Service Bulletin

Bulletin No.: 17-NA-231

Subject: Information on the Replacement of the Video Processing Module Due to Water Intrusion

Brand:	Model:	Model Year:		VIN:		Engine:	Transmission:
		from	to	from	to		
Cadillac	XT5	2017	2017	SOP	June 1, 2017	All	All
GMC	Acadia (VIN N)	2017	2017			All	All

4291116

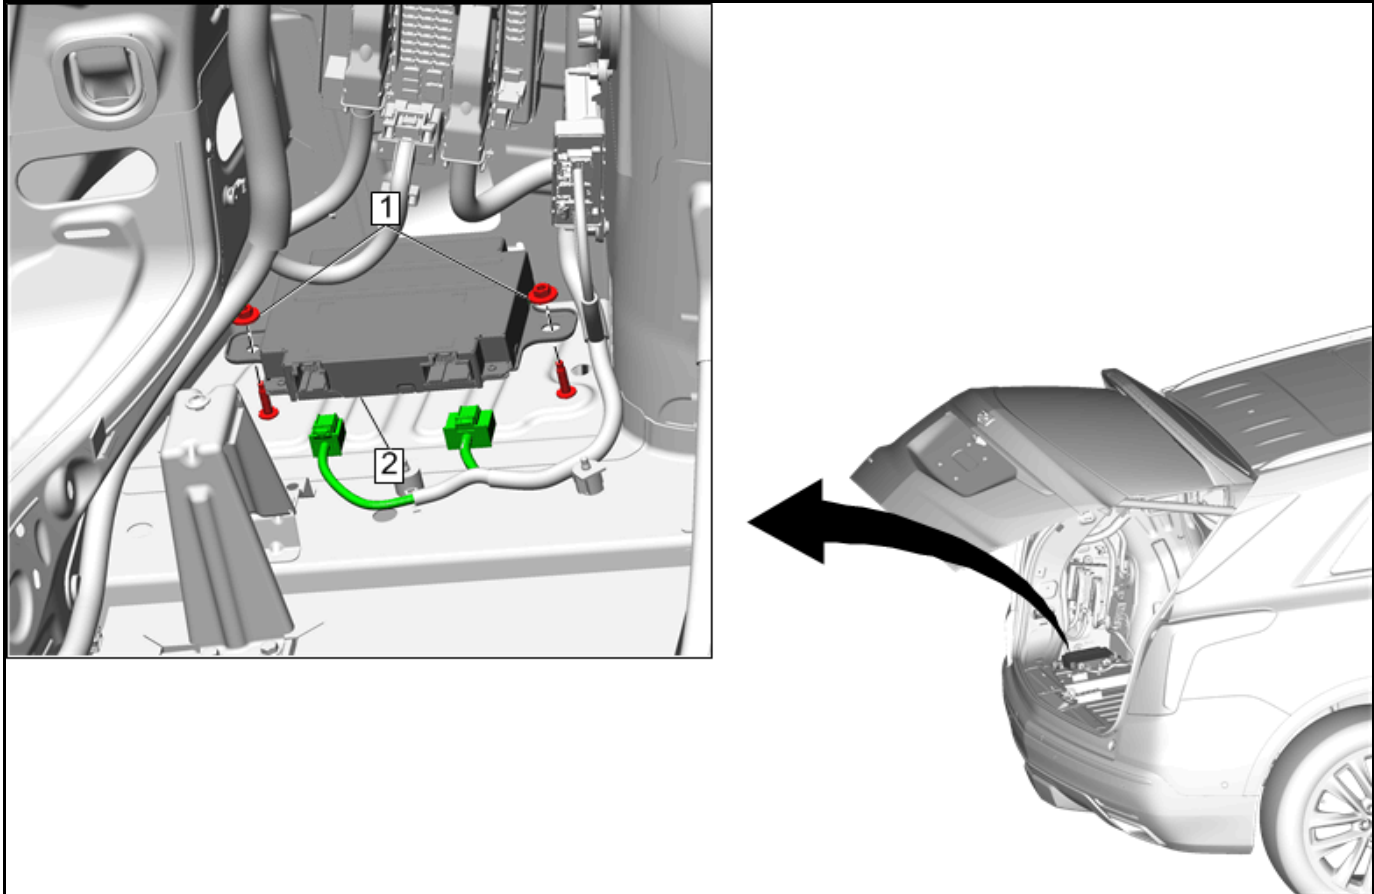
Involved Region or Country	North America, Europe, Middle East and N.A. Export Regions
Additional Options (RPOs)	Equipped with 360 View Camera (RPO UVH)
Condition	During diagnosis, a technician may find that water intrusion caused a malfunction within the Video Processing Module.
Correction	On vehicles built prior to the breakpoint above, remove and replace the Video Processing Module and install two flat washers per mounting stud.

2. Install 2 washers for each stud used to mount the video processing unit.

Note: Be sure to install the washers under the video processing unit, so that the unit is raised from the installation of the washers.
